APPEAL SUMMARY

Appeal ID: 23538	Project Address: 3330 SE 69th Ave
Hearing Date: 3/11/20	Appellant Name: Tim Ayersman
Case No.: B-005	Appellant Phone: 971-200-7213
Appeal Type: Building	Plans Examiner/Inspector: John Cooley
Project Type: commercial	Stories: 3 Occupancy: E, B, A-2, A-3 Construction Type: II-B
Building/Business Name: Portland Public Schools - Kellogg Middle School	Fire Sprinklers: Yes - Fully-sprinklered throughout
Appeal Involves: Reconsideration of appeal	LUR or Permit Application No.: 19-130649-CO
Plan Submitted Option: pdf [File 1] [File 2]	Proposed use: Middle School (Grades 6-8)

Appeal item 1

Code Section	§703.2 Fire-resistance ratings
Requires	§ 703.2 Fire-resistance ratings. Where materials, systems or devices that have not been tested as part of a fire-resistance-rated assembly are incorporated into the building element, component or assembly, sufficient data shall be made available to the building official to show that the required fire-resistance rating is not reduced
Code Modification or Alternate Requested	This appeal was requested by BDS Plans Examiner, John Cooley. The intent of the appeal is to confirm the fire-resistance-rated assembly of a fire wa

11 LOW COLUMN
BRACING AT FIRE WALL
1" = 1'-0"

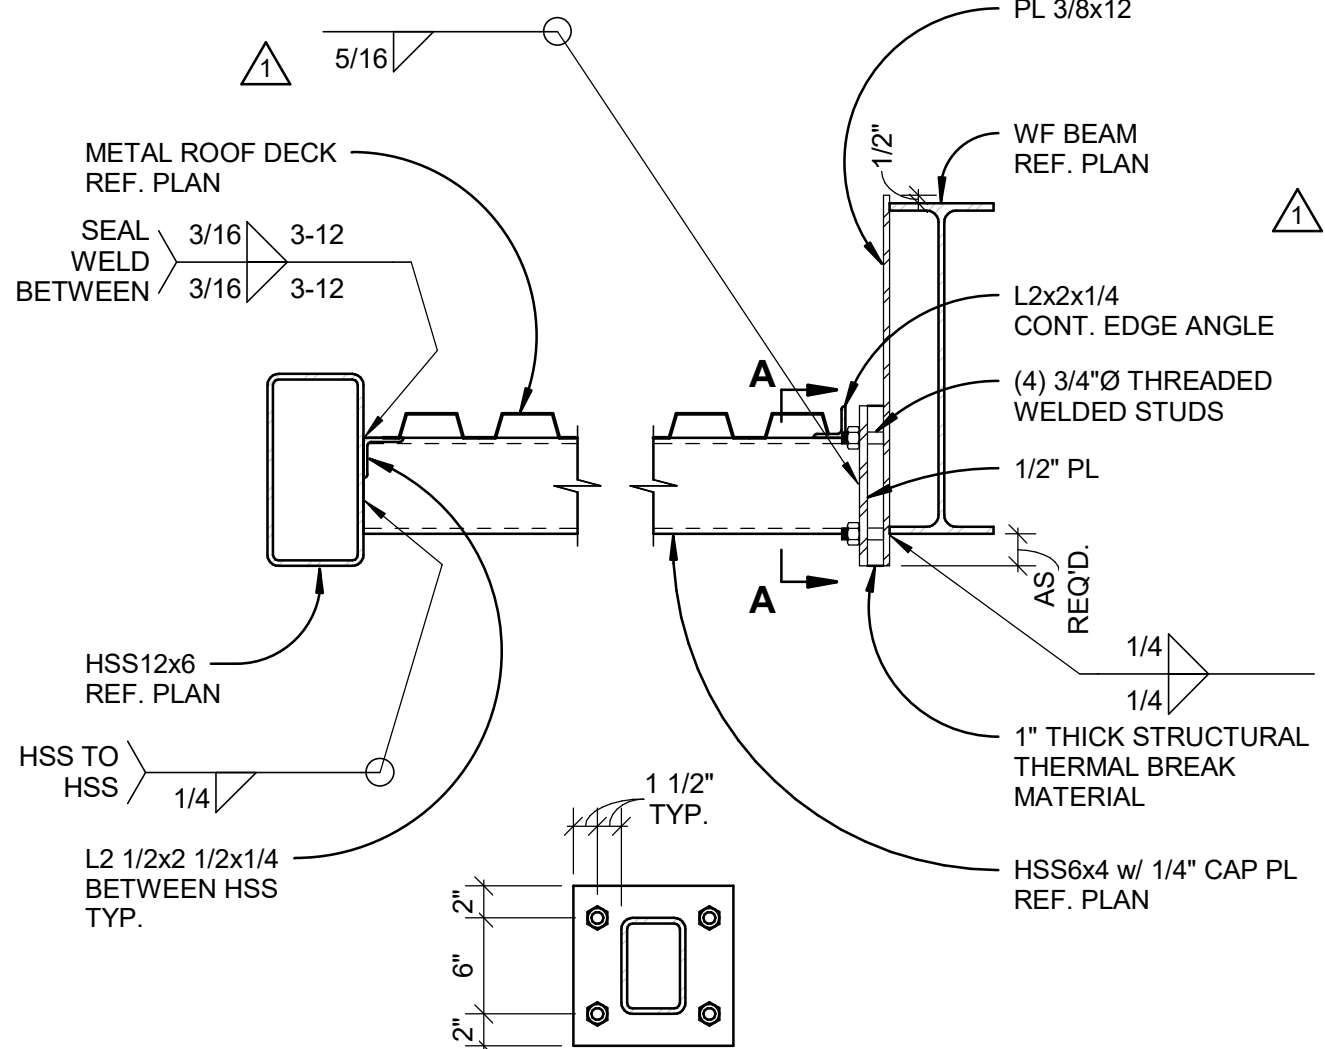
Out-of-plane stability bracing of the low side column to the steel frame on Gridline JJ per Structural Plans Examiner (Greg Wilken) request. 11/S-606
